TOWN OF BLOOMFIELD

**RFP #1165
McMAHON-WINTONBURY LIBRARY
CHILDREN'S GARDEN, SITE & PARKING IMPROVEMENTS**

Question Responses Addendum – December 23, 2025

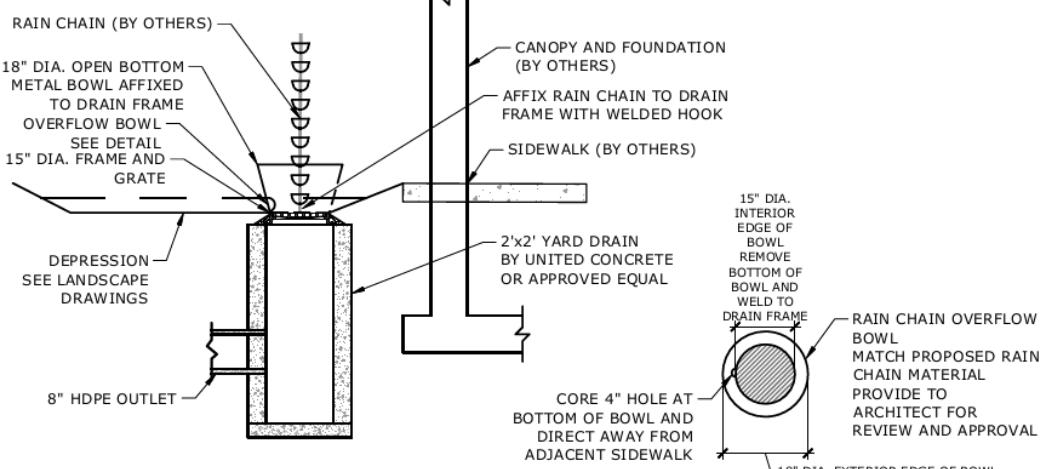
3.	Q.	The yard drain at rain chain connection on C4.0 shows an 18" Diameter open bottom metal bowl. There is no further clarification or specification on this item. Can the design team provide one ?

<p>A.</p>	 <p>RAIN CHAIN SPILL BOWL</p> <p>The detail states that the overflow bowl submittal should be provided to the architect for review and approval.</p>
<p>4. Q.</p>	<p>Could you please send me the loans and the spec book?</p>
<p>A.</p>	<p>. The "spec book" is the project manual specifications section attached to the original posting on the Town & State DAS websites. No clue what it meant by "loans".</p>
<p>5. Q.</p>	<p>What is the proposal response date?</p>
<p>A.</p>	<p>The response date is no later than January 26, 2026, at 1:00pm.</p>
<p>6. Q.</p>	<p>Specification section 010401 -2.1 Materials F. Square metal posts notes "Shall be indicated on the contract drawings" there is no indication of square metal posts on the drawings. Please identify where square metal posts are used on the project and the requirements for the material to be used.</p>
<p>A.</p>	<p>This specification is generalized, and I do not see square posts identified on the contract drawings. Site General Notes L0.00-</p> <p>16. ALL SIGNS AND PAVEMENT MARKINGS SHALL CONFORM TO THE "MANUAL ON UNIFORM TRAFFIC CONTROL DEVICES" (MUTCD), AND THE LATEST STATE OF CONNECTICUT CATALOG OF SIGNS AND STANDARDS AS REVISED.</p> <p>17. CONTRACTOR SHALL SUBMIT SHOP DRAWINGS AND PRODUCT INFORMATION FOR ALL SIGNS, SIGN POSTS, FASTENERS AND PAVEMENT MARKINGS FOR REVIEW AND APPROVAL BY THE CIVIL ENGINEER, LANDSCAPE ARCHITECT AND THE OWNER.</p>
